From: [Alexander Harding](#)
To: [Canton, Aaron](#); [Transportation Commission](#)
Subject: West Towne Path phase 3: Commerce Drive needs a diet!
Date: Friday, May 20, 2022 12:43:10 PM
Attachments: [PastedGraphic-1.tiff](#)

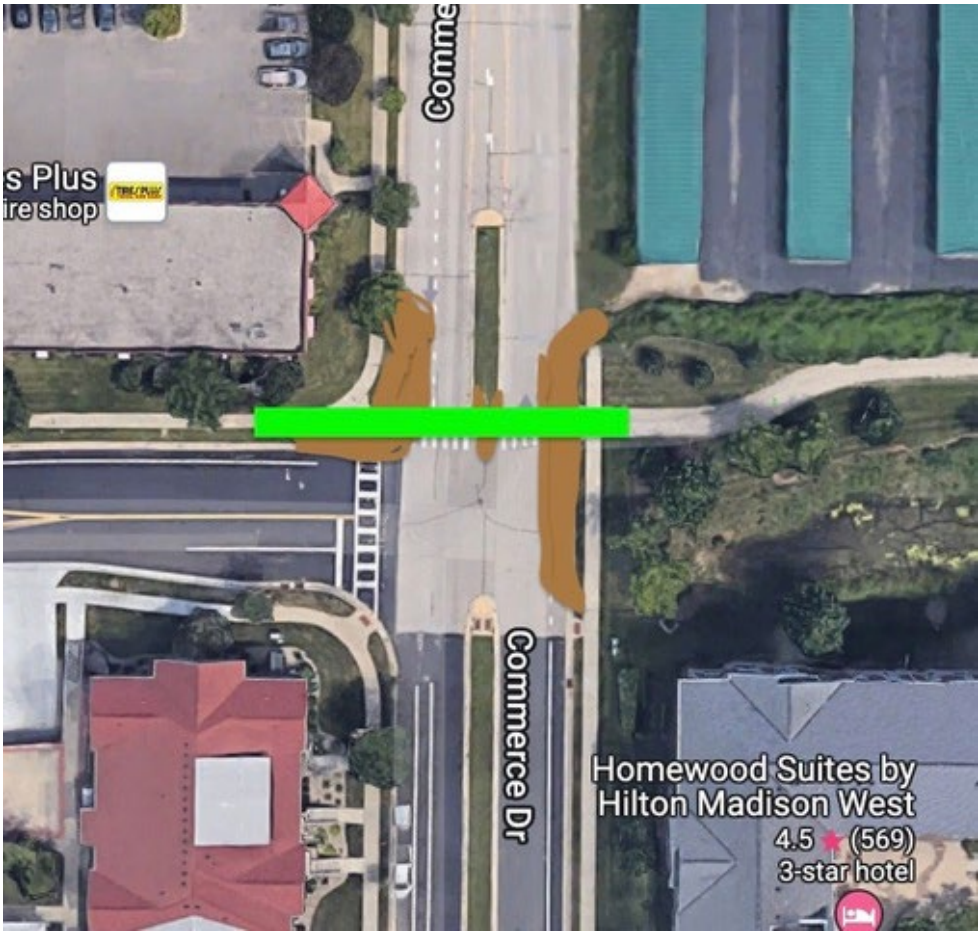
Commerce Drive is 5 lanes. It has <10k VPD. It has **ZERO** bike lanes, sidewalk on one side **without terrace**. This is a textbook candidate for a road diet.

Why are you planning on maintaining these unnecessary travel lanes with the West Towne Path proposal?

It should be reduced to one lane per direction, there should be bump outs at the crossing, **and the crossing should be continuous!**

Take the opportunity to road diet Commerce Drive to tighten up the crossing! Road diets are proven by the FHWA to reduce crashes 19-47%!
